MPX-2ds/2d

Version 1.04-rc4

09.04.2026

MPX-2ds/2d Release Candidates Notes

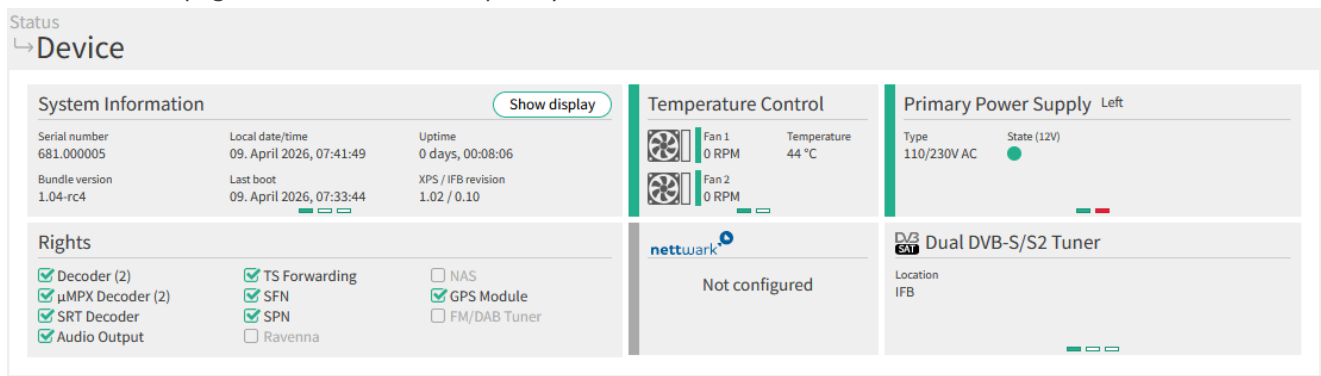
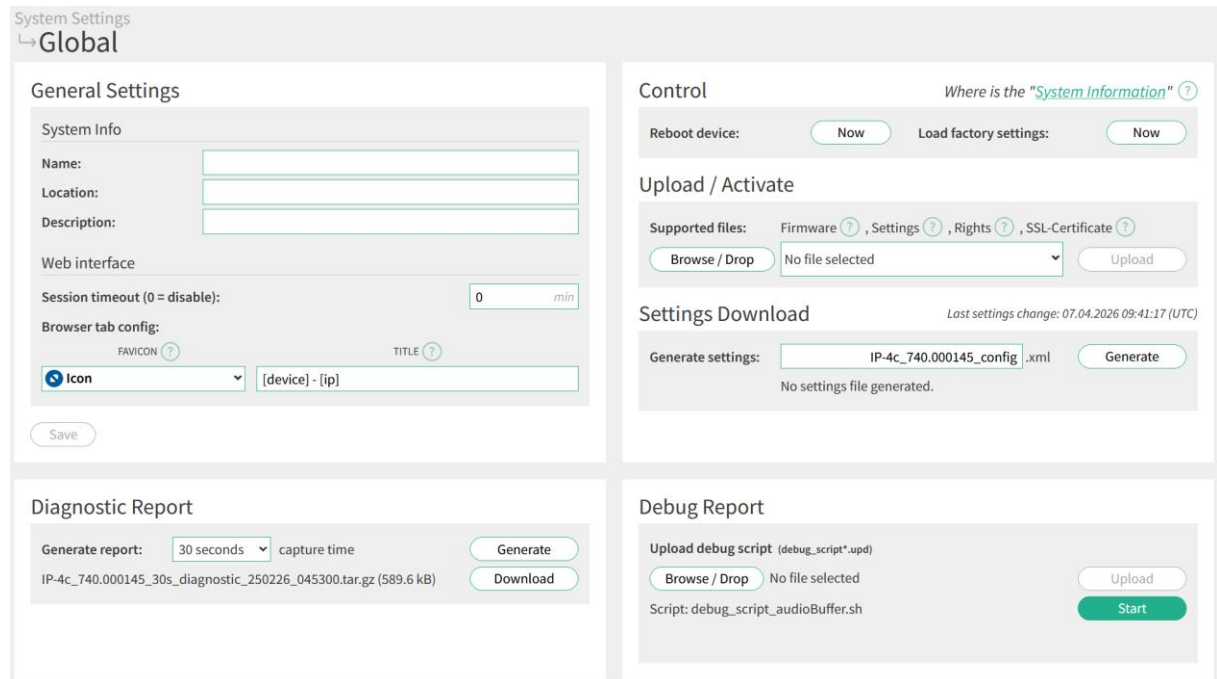
- Added display for the installed SAT tuner (see new Status/Device page)
- The System Information, which was formerly found under System Settings / Global, has been moved to the Status / Device page, which has been completely revised

The System Settings / Global page looks therefore of course different now, too:

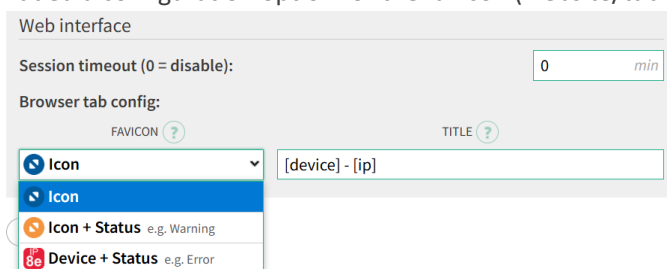
- Added a configuration option for the favicon (website/tab icon)

You now have the possibility to show the overall status of the device via the icon color. You might even show the device type via the icon for better differentiation in case of many open browser tabs.
